## ORIGINATION FORM

Proposed Revisions to a Standard Plans Index  
(Please provide all information — Incomplete forms will be returned)

Index Number: 715-002  
Sheet Number (s): 1, 2, 4, & 7  
Index Title: Standard Aluminum Lighting

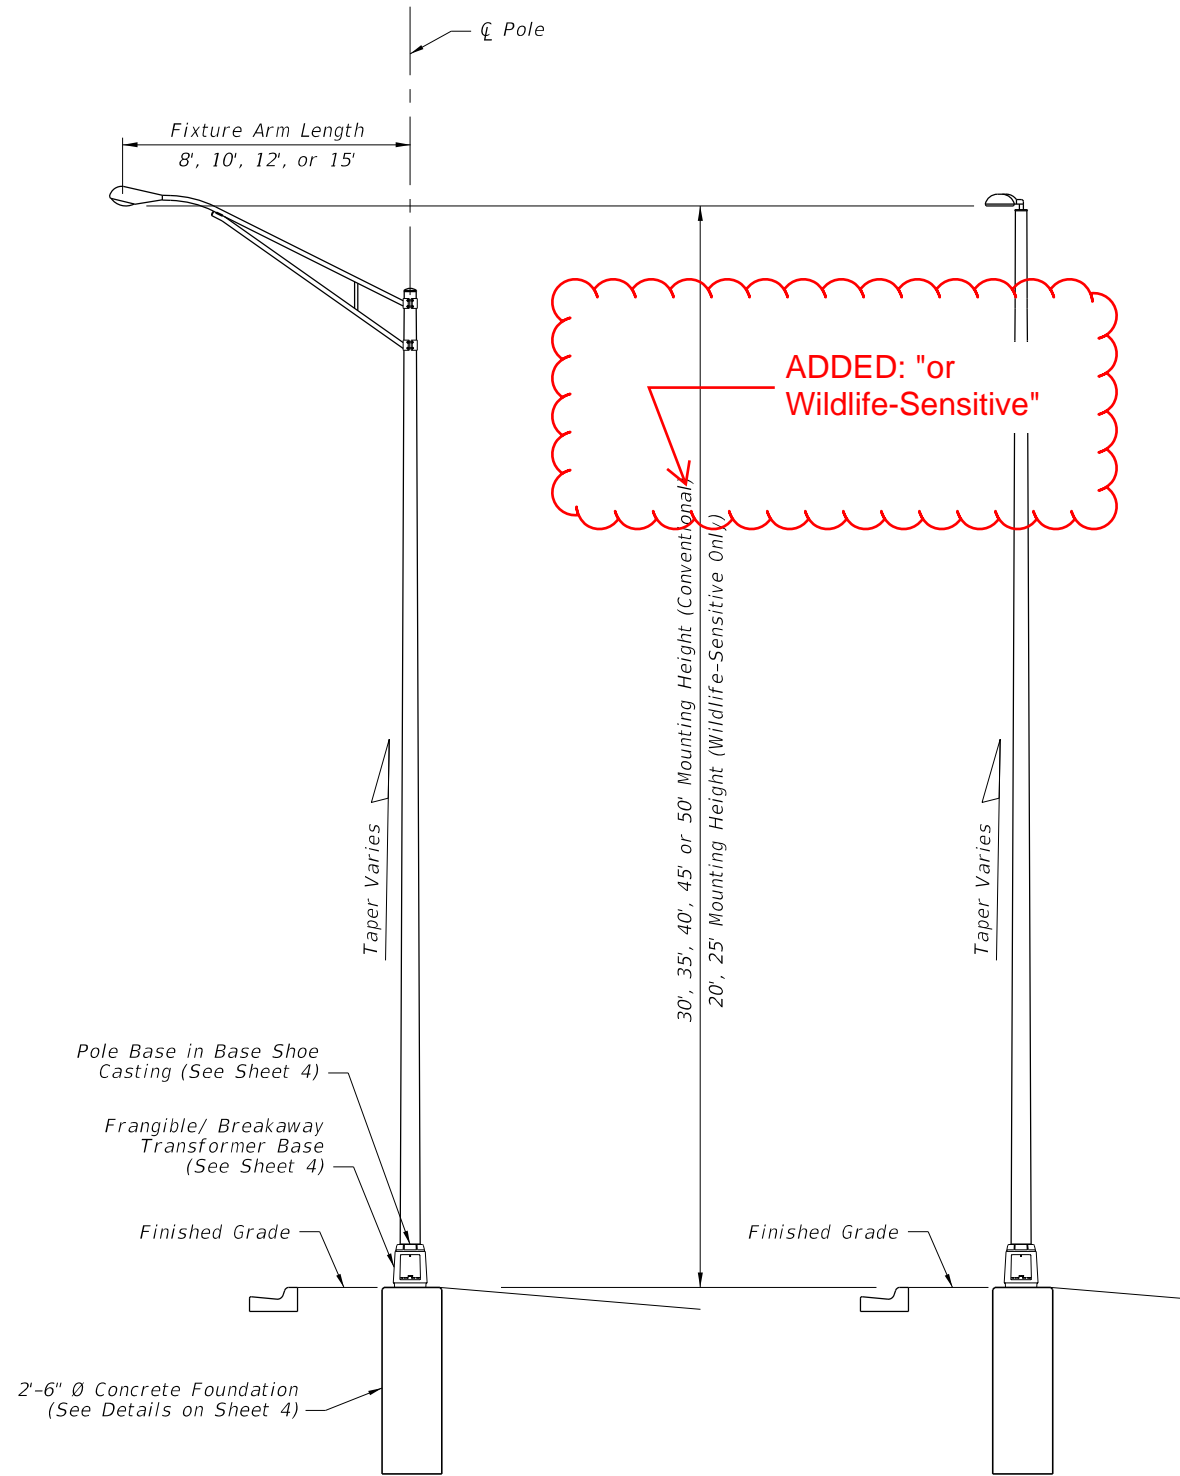
Sheets 1, 4, & 7: Changed general concrete requirement from Class I to Class II.

CHANGED TO: Class II

- I. Stainless Steel Fasteners: ASTM F593 Alloy Group 2, Condition A, CW1 or SH1
  - J. Nut Covers: ASTM B26 (319-F)
  - K. Concrete: Class II
  - L. Reinforcing Steel: Specification 41

ELEVATIONS

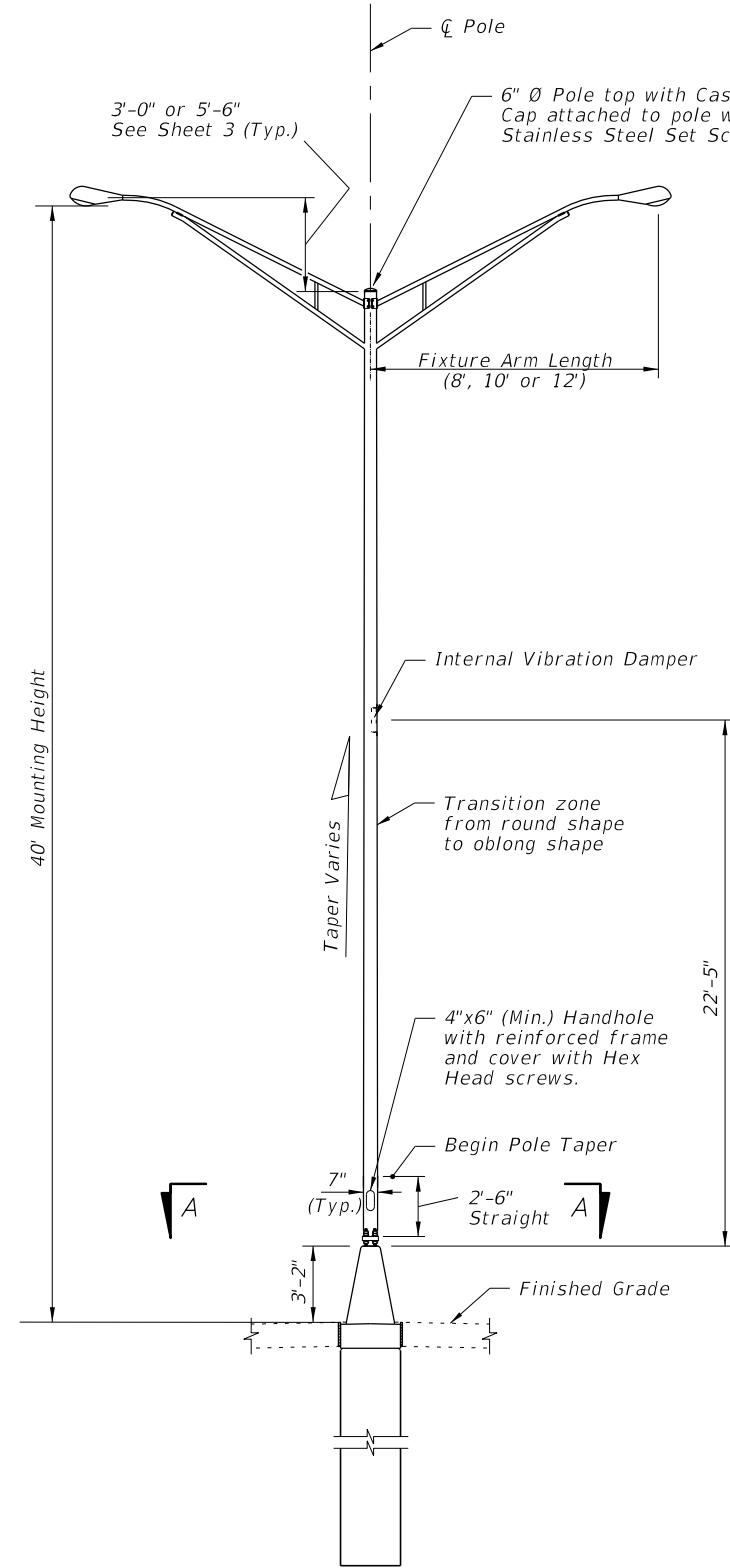
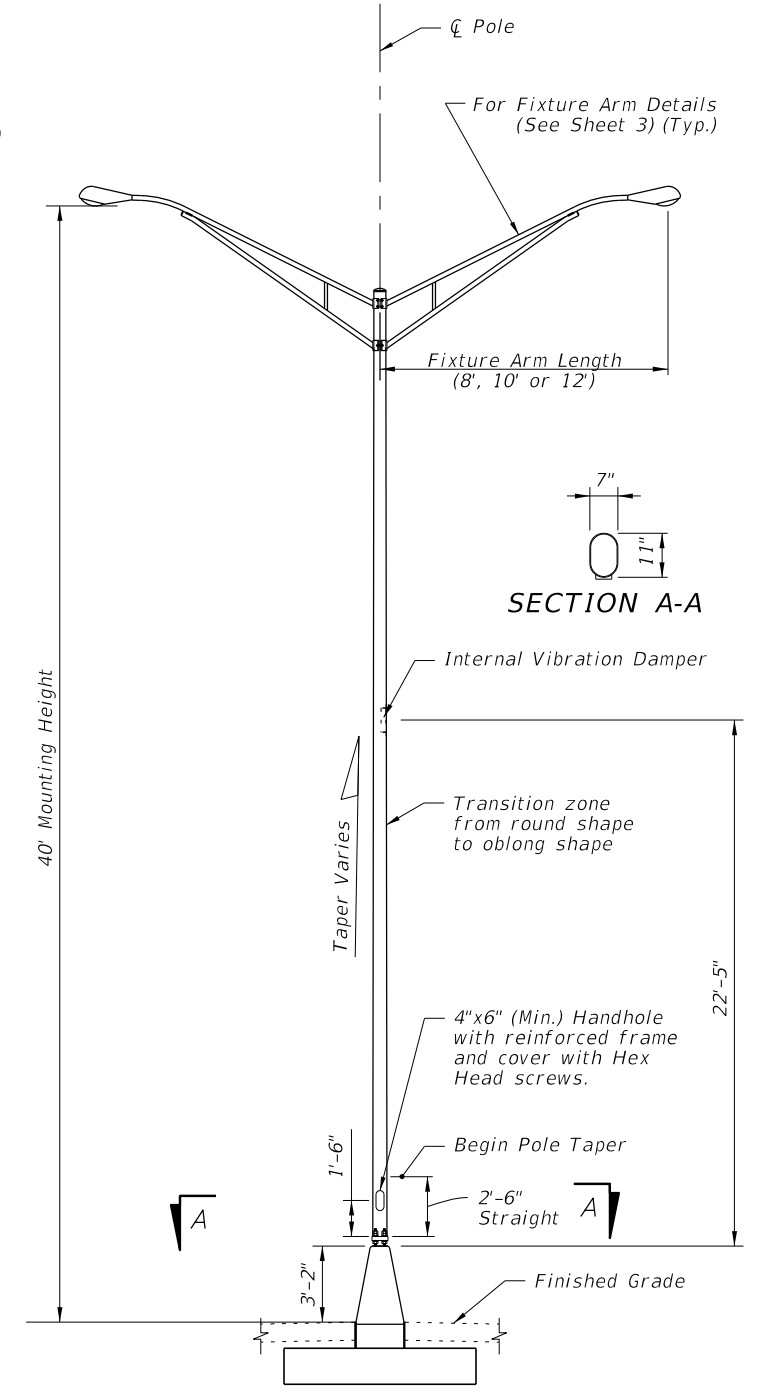
Sheet 2: Added clarification to callout. Wildlife-Sensitive lighting may also be used with standard mounting heights 30 feet through 50 feet (original intent).

Wildlife-Sensitive: Added clarification for allowable luminaire mounting height based on District comment

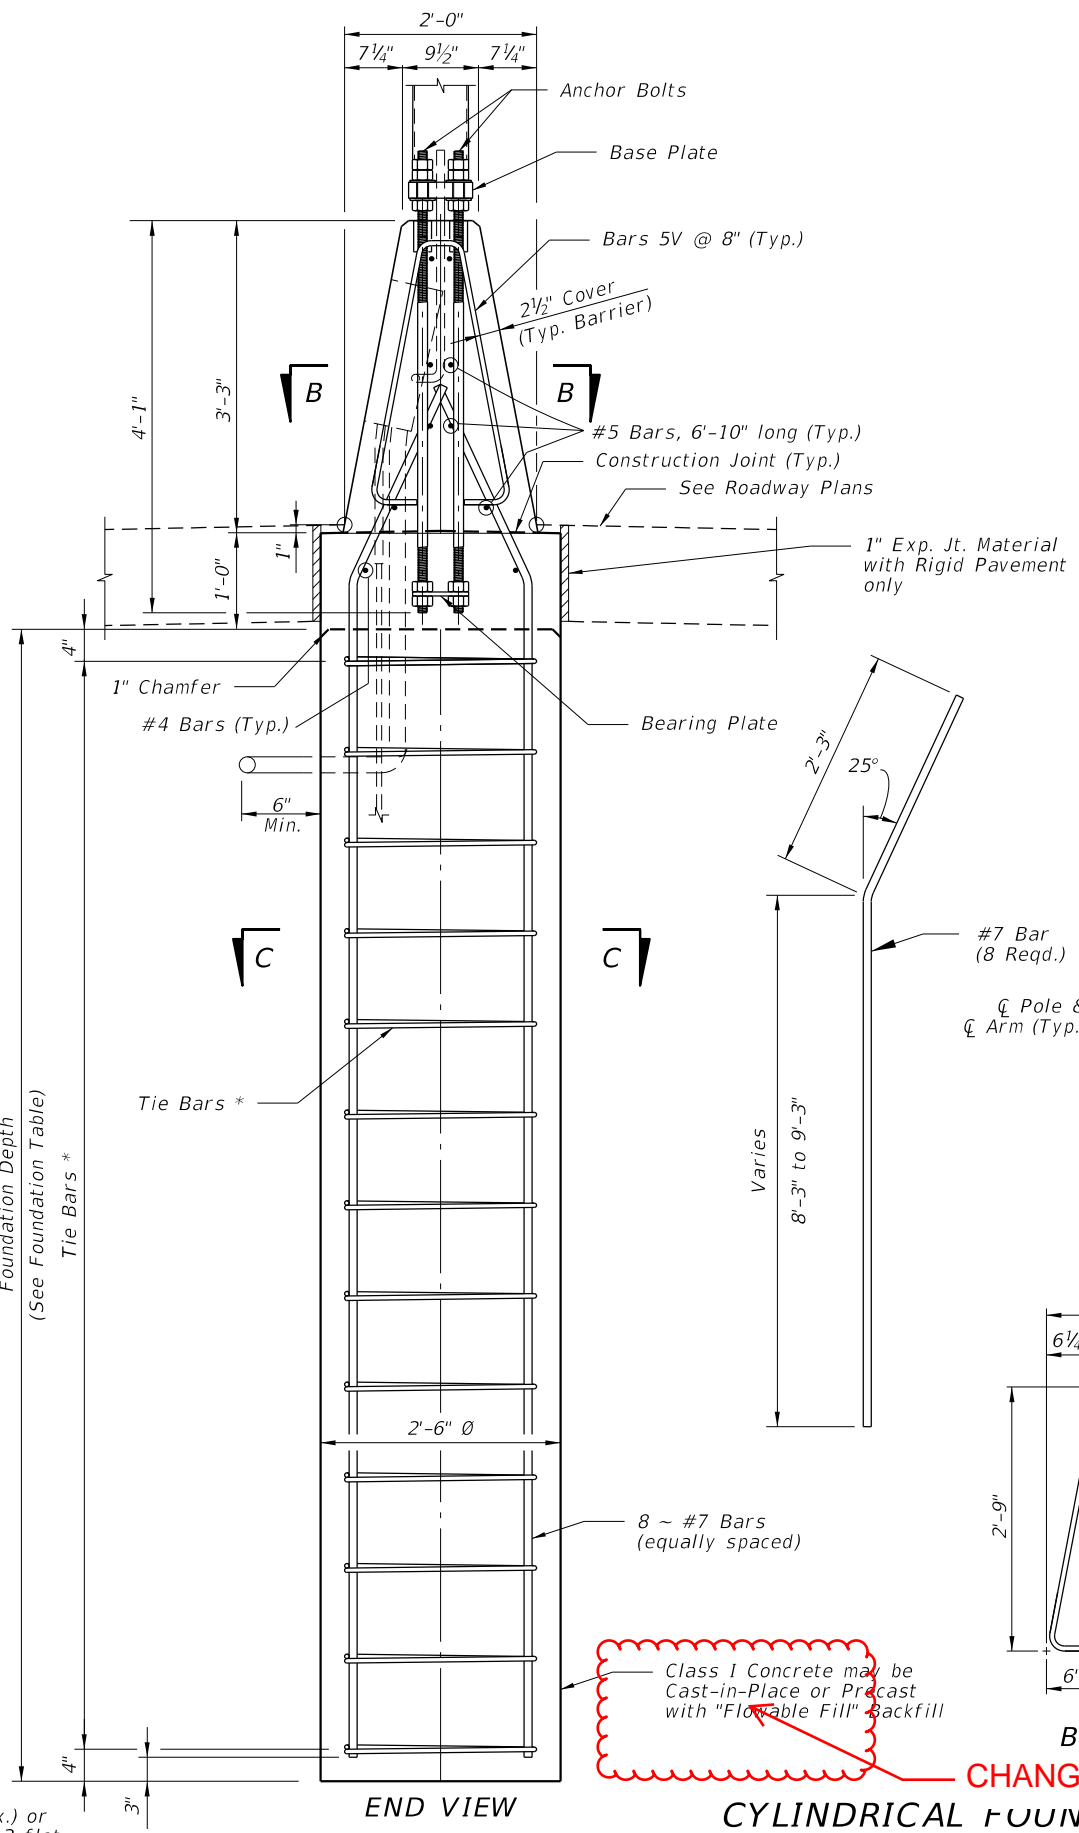
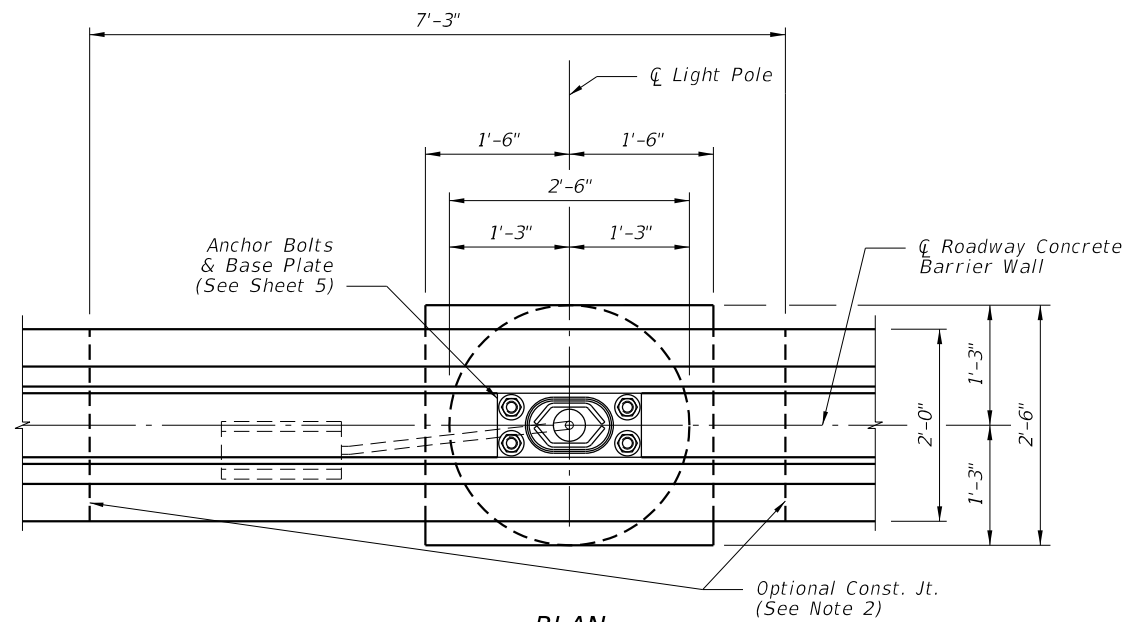
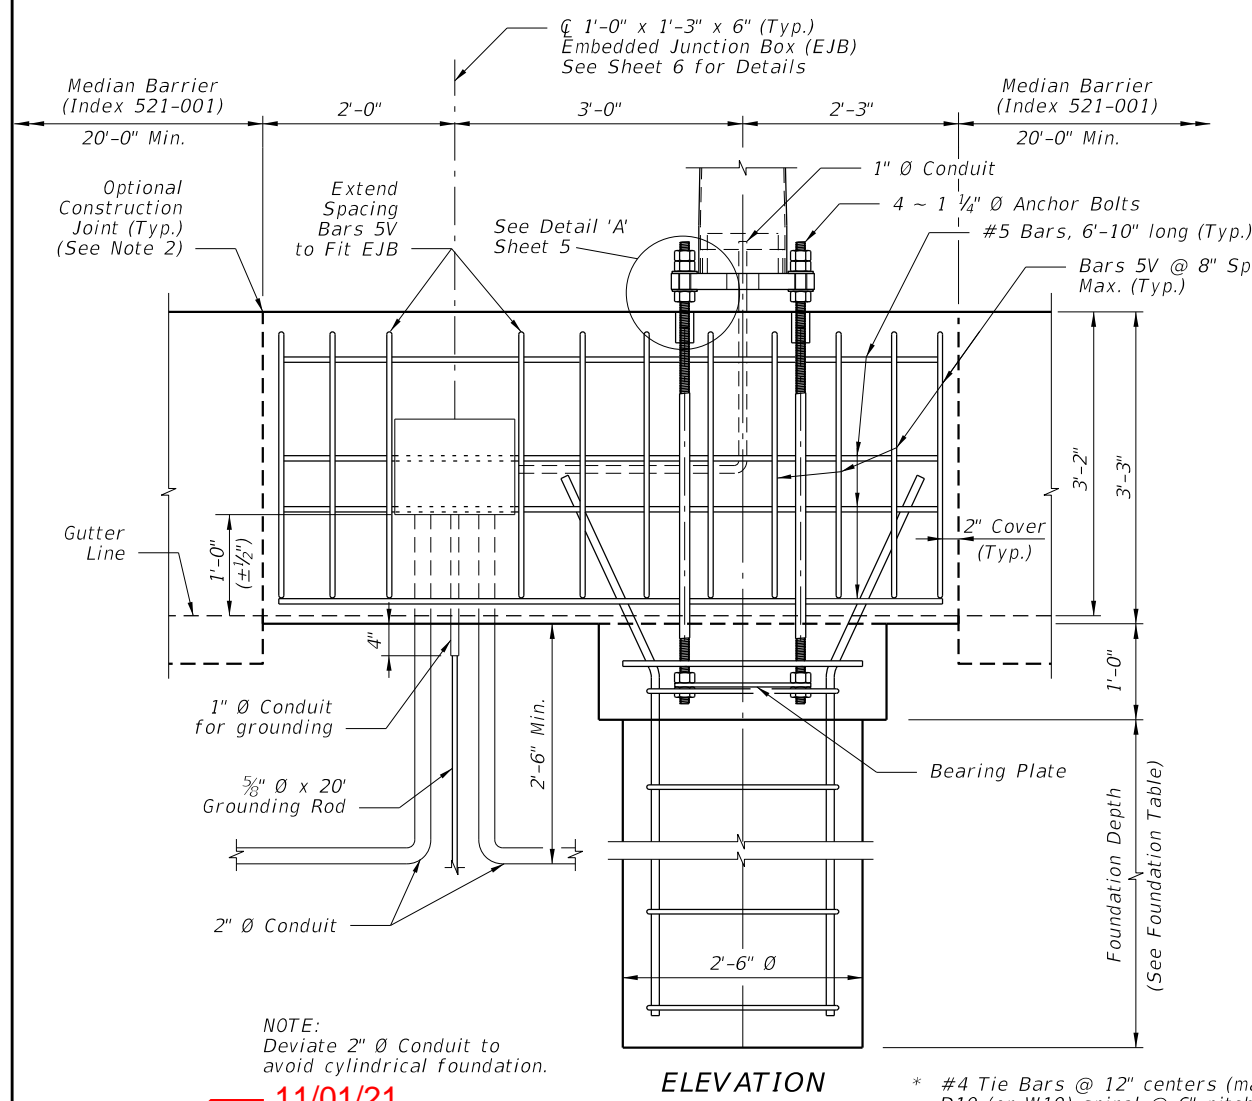
Class I Concrete may be Cast-in-Place or Precast with "Flowable Fill" Backfill  
**CHANGED TO: Class II**
